Valley County Planning and Zoning

STAFF REPORT:	CUP 26-019 Wipf Solar Panels
MEETING DATE:	August 13, 2026
TO:	Planning and Zoning Commission
STAFF:	Cynda Herrick, AICP, CFM Planning and Zoning Director
APPLICANT / PROPERTY OWNER:	Mark Wipf, MAW Properties LLC, 11259 Parleys Cone CT, Las Vegas NV 89135
REPRESENTATIVE:	Claire Cameron, RevoluSun Mountain States 457 Steelhead Way, Boise ID 83704
LOCATION:	14110 Norwood Rd Parcel RP18N03E283605 SWNW Section 28, T.18N, R.3E, Boise Meridian, Valley County, Idaho
REQUEST:	Ground-Mounted Solar Panel Array
EXISTING LAND USE:	Single-Family Residential Parcel with Home

Mark Wipf is requesting a conditional use permit to construct a 51-ft 3-inch x 10-ft 11-inch ground-mount solar array. The array would consist of modules in three strings of eighteen, arranged across two pole-mounted structures.

SITE PLAN

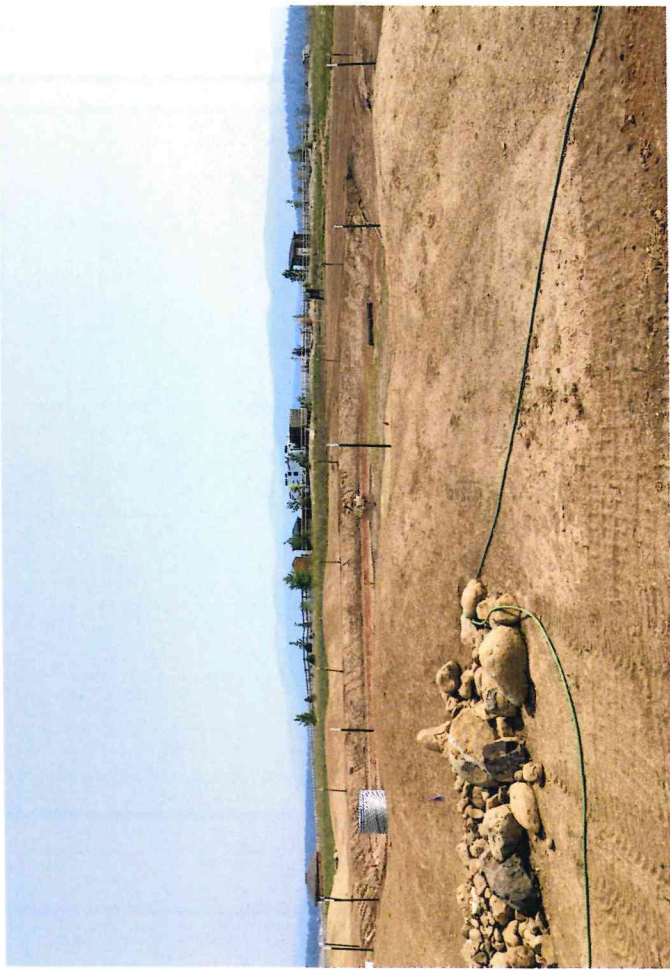
1. This site is within the McCall Fire District, Water District 65K, Lake Irrigation District, and a herd district.
2. Building permits will be required for the solar panel arrays.
3. Does the P&Z Commission want to require screening on the SW and NW corners to protect view corridors along Norwood RD?
